PERMIT

P 29849
A Repair

SEWAGE DISPOSAL SYSTEM

SUBDIVISION _____ ROAD 11120 Douglas Road LOT _____

P29849

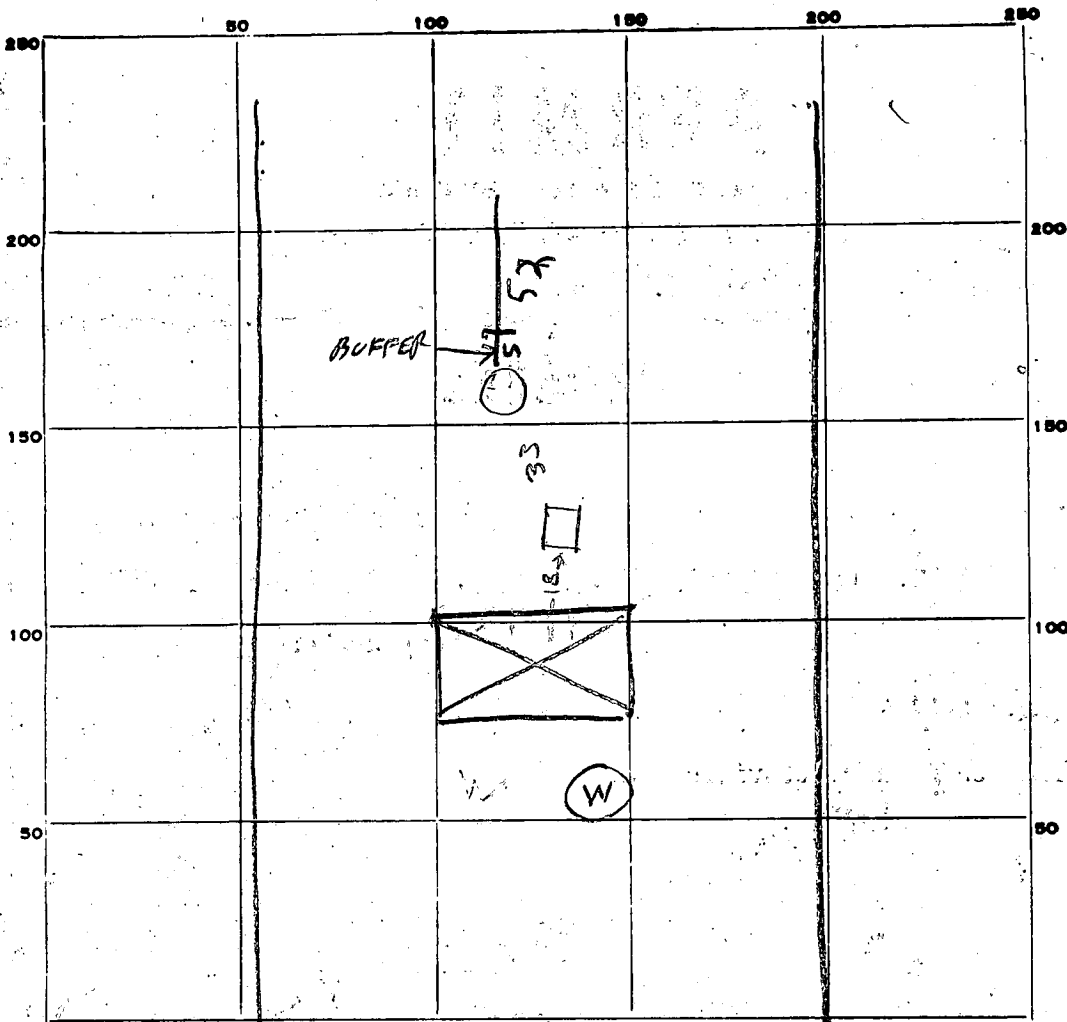
REPAIR - Call for an appointment when ground is opened up and Sanitarian will

recommend repair system. 6/20/79 DITCH 71 FT DEEP

OFF STONE 360 SQ FT SIDE WALL AREA

OFF OLD D.W.F.

REMARKS 6/20/79 AM SOIL VERY SANDY & 11 1/2 FT 50

DEEP DITCH DUG AM

6/20/79 PM - STONE & PIPE ADDED TO DITCH

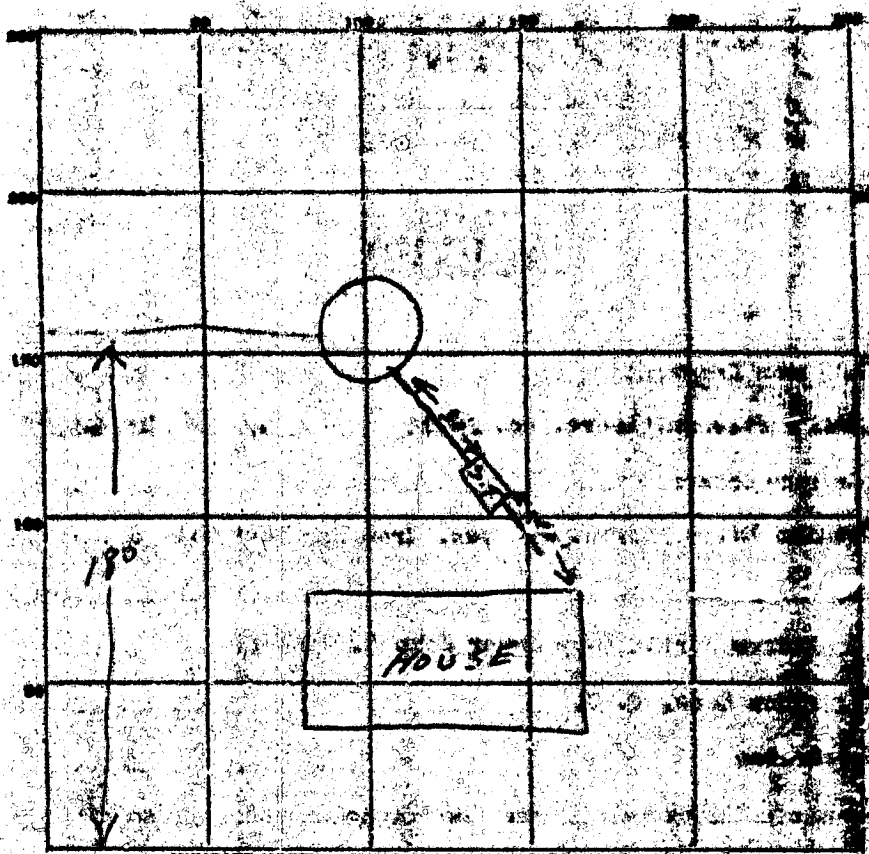
REMARKS 6/15/64 Well to wall diameter 15" 3ft of footage
Dry Well top not properly set. Six inches of stone around
dry well has required. Several need to be laid to top
course of block. Right hand side of Dry Well in the side
that does not have 6" of gravel. J.D.L.
